AMENDMENT NO. 1

CAPRICORN NEIGHBOURHOOD CENTRE

AGREED STRUCTURE PLAN NO. 54

AMENDMENT NO. 54

Image 15: Potential for building adaptability

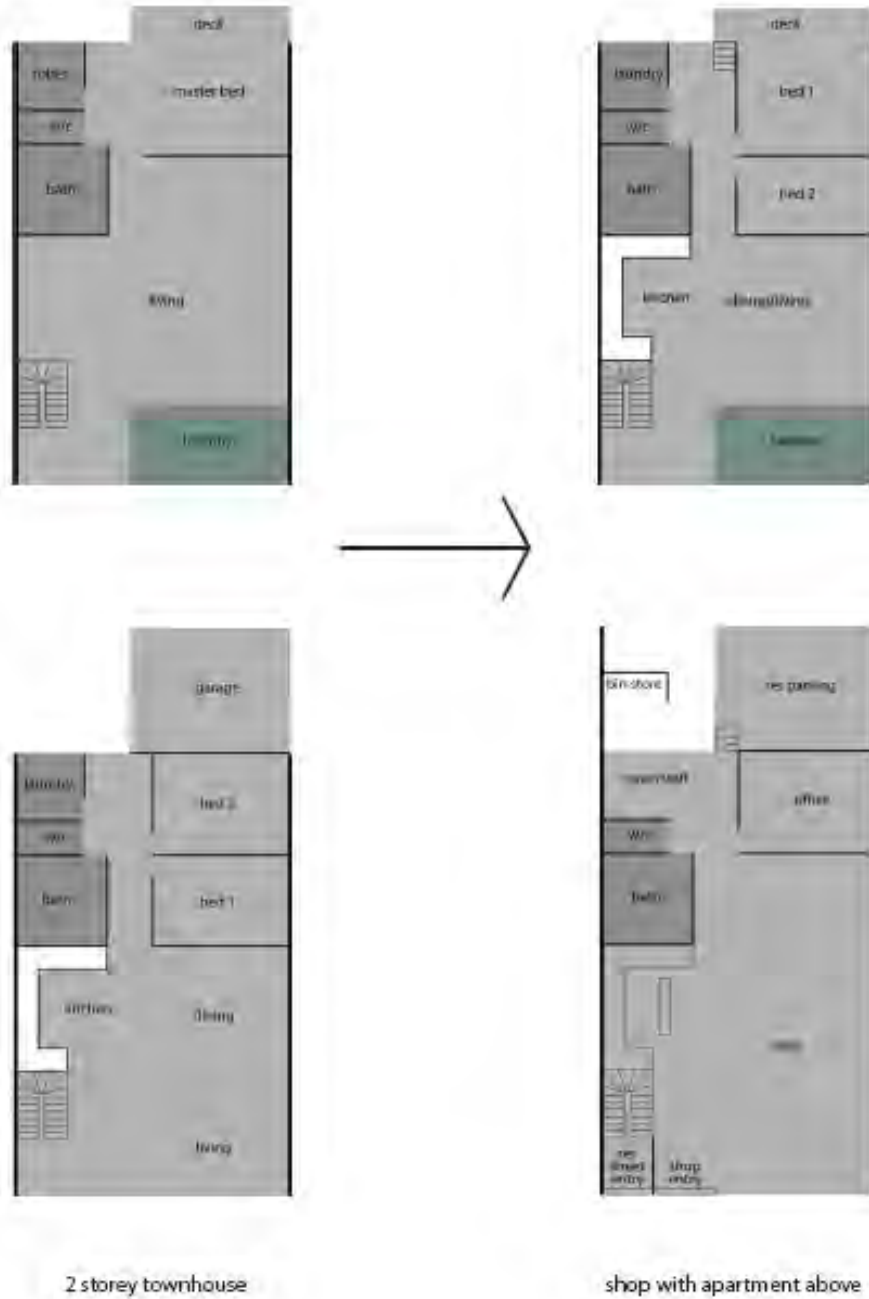
Adaptability (Image 15)

- Part 1 of the LSP ensures the adaptability of buildings within the Village Centre allowing them to respond to changes of use and dwelling size over time.
